Technical Service Bulletin: TSB210055 Released Date: 03-Nov-2022

New Fuel Rail, High Pressure Injector Supply Lines, Fuel Supply Line, Fuel Supply Line Braces, and Pressure Relief Valve

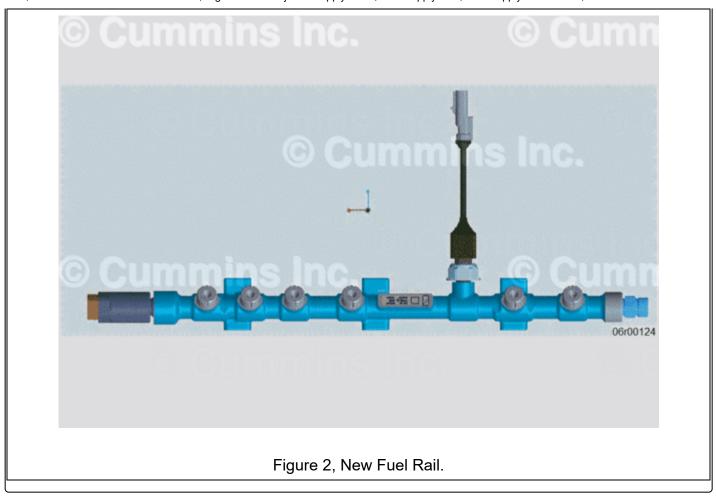
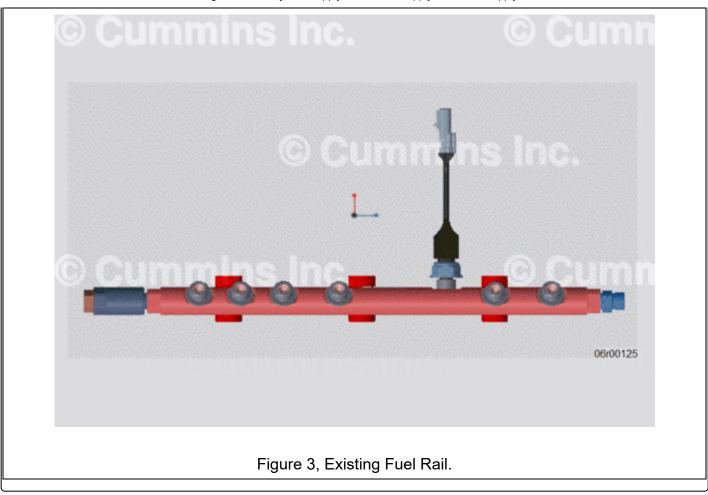
1. New fuel rail can be identified by the shape.

2. High pressure injector supply lines can be identified by the shape.

Figure 5, Existing High-Pressure Injector Supply Line, Part Number 4937931 (Injector 1).

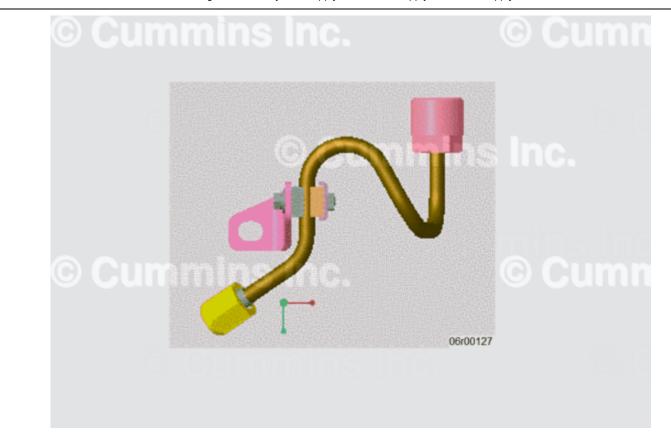
A new fuel rail is available along with new high-pressure injector supply lines, fuel supply line, and fuel supply line braces. The new fuel rail is **not** compatible with the existing high-pressure injector supply lines.

- If existing fuel rail has malfunctioned, replace with the new fuel rail.
 - New high-pressure injector supply lines **must** be used with the new fuel rail.
 - New fuel supply line and new fuel supply line brace must be used with the new fuel rail.
 Replace the existing brace with only one corresponding new brace part number. See
 Table 1.
- If the existing high-pressure injector supply line has malfunctioned, replace with new highpressure injector supply line.
 - Do **not** replace the fuel rail.
- If the existing fuel supply line has malfunctioned, replace with new fuel supply line.
 - o Do not replace the fuel rail.
